OSM/LUM DECISION SHEET (DSH)

Standard(s) (incl. year)	Subclause(s):	Tracking No.	Year
IEC 60598-1 (6 th & 7 th edition)	4.14	DSH 0861	2014
Category:			
LITE			
Subject:	Key words:	Developed by	
Suspension devices	<ul style="list-style-type: none"> - Additional weight - Point B and/or C - Design 	ETF5-OSM/LUM

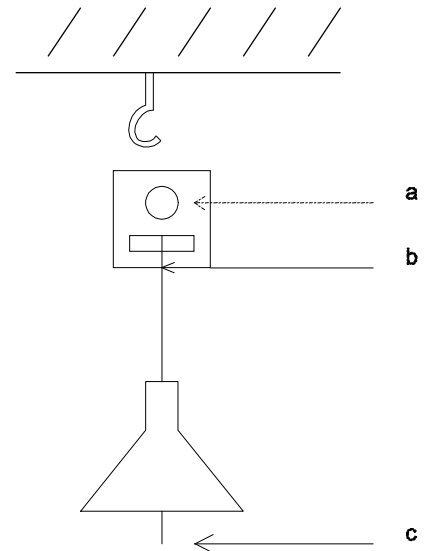
Where is the additional weight of 4 times the luminaire's weight supposed to be put on a pendulous luminaire? On point A, B or C of the attached figure?

Depending on the design on point B and/or C.

In the 8th Edition of IEC 60598-1, the test A has been modified and clearly states that the test shall be done also for the external parts attached to the luminaire.
